DIVISION 6. - "RIO" DISTRICTS

Sec. 35-670. - Criteria for Certificate of Appropriateness—Generally.

Figure 672-1

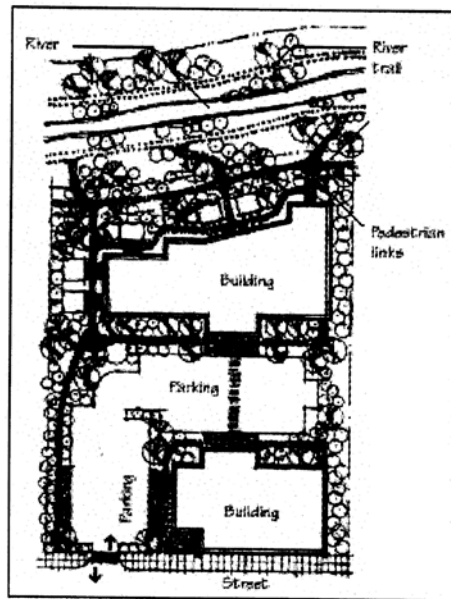
[Renumber Figure to 672-3](#)

Figure 672-2

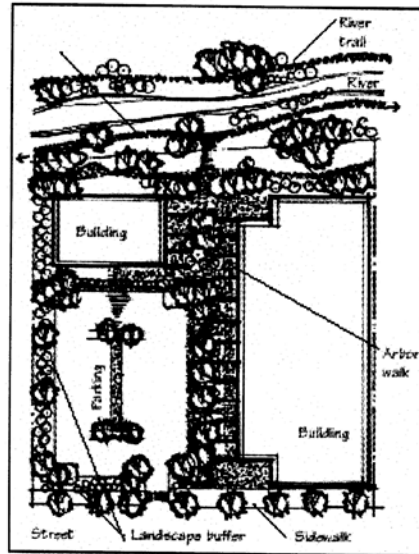
[Renumber Figure to 672-4](#)

Figure 672-3

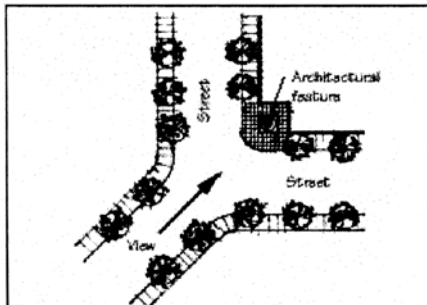
[Renumber Figure to 672-5](#)
